Subject: Snowy 2.0 Main Works Environmental Impact Assessment – EES Submission

ATTACHMENT A – Assessment Summary for Snowy 2.0 Main Works (SSI 9687)

ATTACHMENT B - Detailed BDAR review against BAM requirements

Attachment B: Detailed BDAR review against BAM requirements

Snowy 2.0 Groundwater drawdown area, vegetation mapping and survey effort

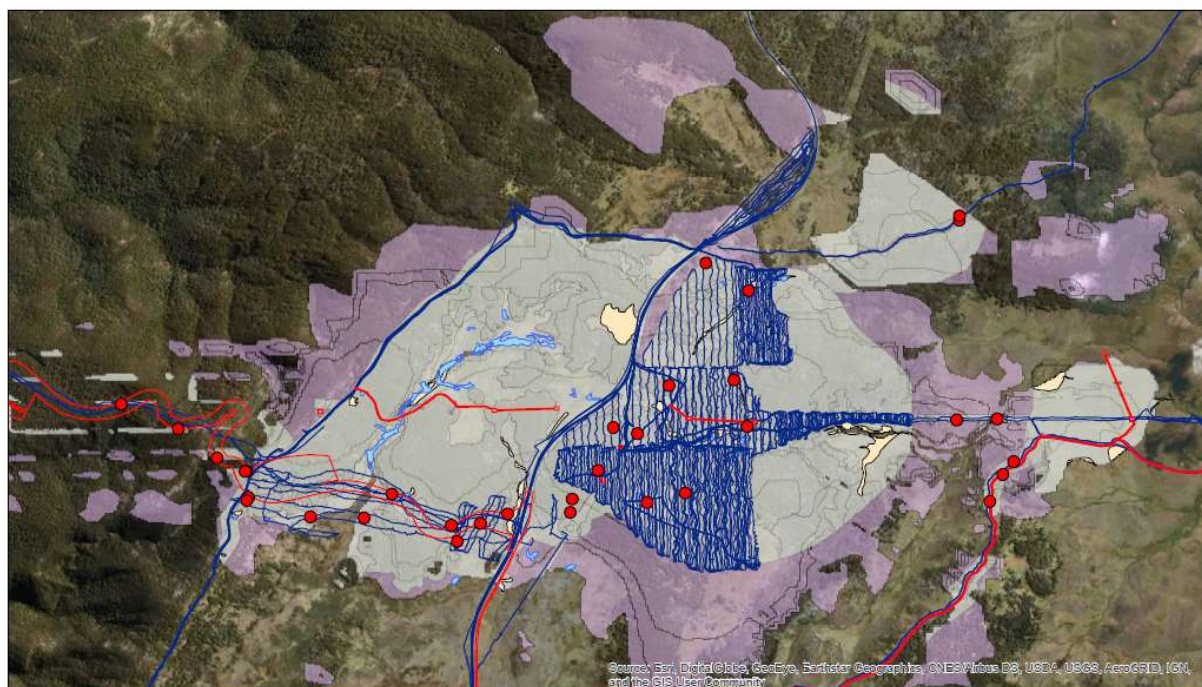
- the total groundwater drawdown area is 2510 ha (purple area, Figure 1).
- the area of groundwater drawdown which has been subject to vegetation mapping is 2,175 ha, or 86% of the total drawdown area. Therefore, there is 335 ha of unmapped vegetation within the drawdown area (purple area, Figure 1).

- of the vegetation that is mapped within the drawdown area (ie the 2,175 ha), there are 48 BAM plots (red points, Figure 1) covering the vegetation zones shown in Table 1. There is a subset that has also been subject to rapid vegetation survey (blue line, Figure 1)

- the total area of obligate groundwater dependent PCTs within the groundwater drawdown footprint is 28.3 ha (cream area, Figure 1). This is comprised of the following PCTs:

- The total area of bogs within the groundwater drawdown footprint based on Hope's mapping is 12.05 ha. This area was not subject to BAM plots or rapid survey by the Proponent.

- It's clear from the mapping of an overlay of the vegetation mapping within the drawdown area as well as the location of the BAM plots that there are large swathes of vegetation that have not been subject to any survey. Furthermore, the placement of the BAM plots has clearly not been randomly stratified as they are clustered around road access points.

- Note as well that only small fraction of the drawdown area is considered to be directly impacted (red line, Figure 1). This is as a result of the pipeline

Further survey and assessment of drawdown impacts areas would be required to form baseline data for monitoring surveys and determine potential credit obligation and offset requirement.
